Docket Items # 3  
BAR CASE # 2011-0054

**ISSUE:** Alterations and Waiver of Section 7-202 (Height Requirement)

**LOCATION:** 227 South Fairfax Street

**BAR CASE #2011-0054**

Figure 1: Plat – Yellow Lines denote brick walls to be altered

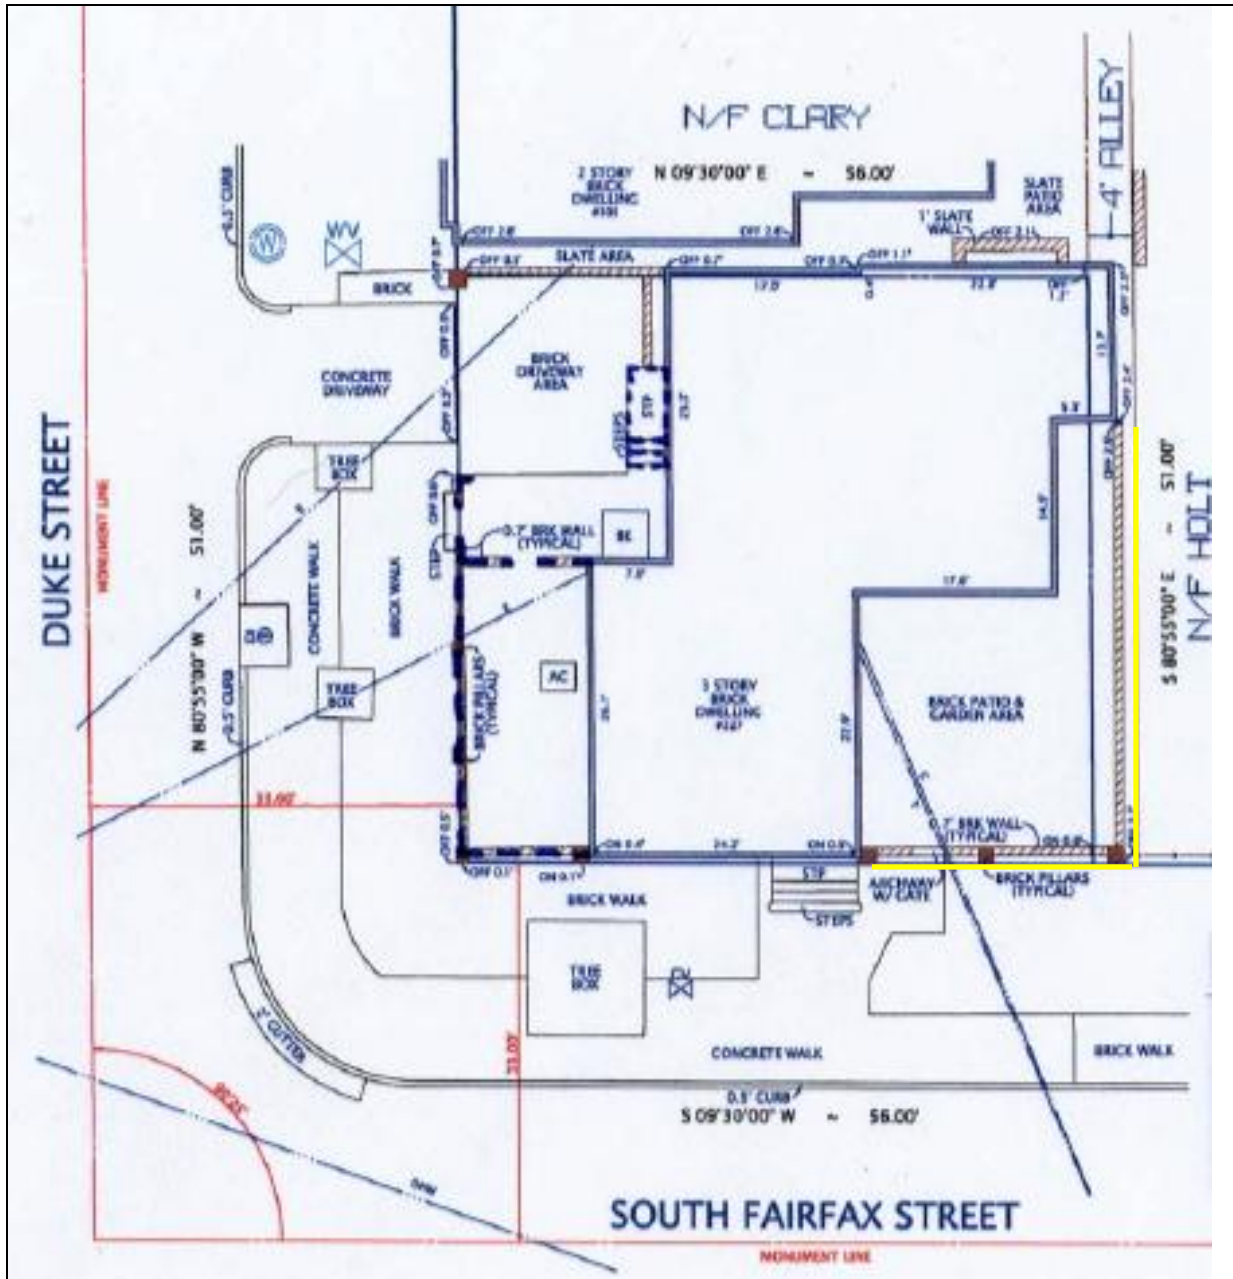
1. A Certificate of Appropriateness for alteration to the existing brick garden wall, which encloses the North courtyard. The proposal will increase the overall height of the existing garden wall to 6'-10" (15" higher than existing) by adding 5 courses of common bond brick.
2. A Waiver for the proposed brick wall height in excess of 6' high (per Section 7-200(C) of the Zoning Ordinance).

The proposed alterations to the existing garden wall surrounding the North courtyard complies with zoning ordinance requirements if the BAR grants the waiver to Section 7-202(C), which would permit a brick wall beyond the permitted six feet in height.

Figure 3: c1967 Photo of Front Façade with wood fence

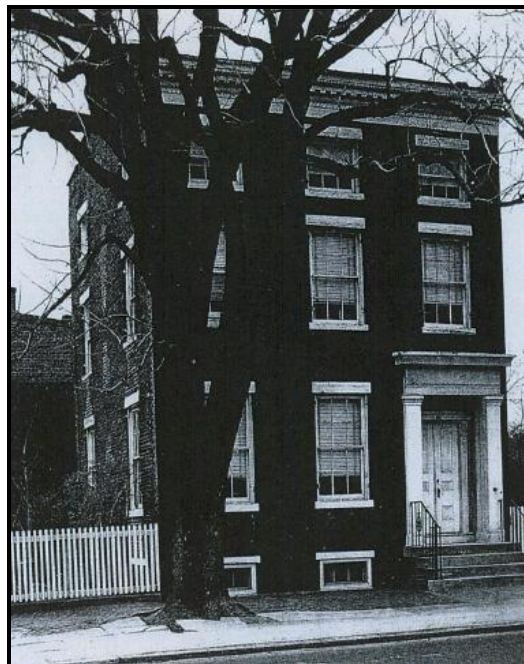
The north and south courtyards were enclosed with a 5'-7" high brick wall constructed after 1967. (The below c1967 photo illustrates that a wood picket fence previously enclosed both courtyards).

**Figure 4: Photos of Existing brick wall**

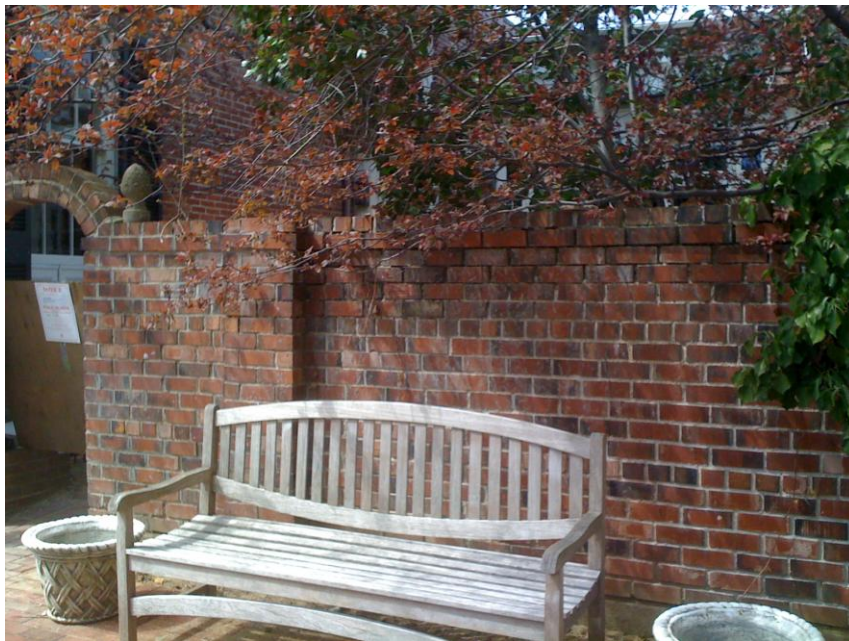
The applicant will be articulating the existing brick wall with an additional five courses of brick set upon the cap of protruding stretcher and rowlock bricks (see photo below).

In Staff's opinion, the proposed changes to the garden wall meet the requirements of the *Design Guidelines*. The height of the wall is consistent with other existing walls within the district and will not damage existing historic features on the subject property. Due to the differences in grade, the new interior height of the wall will rise to six feet (6') high within the garden.
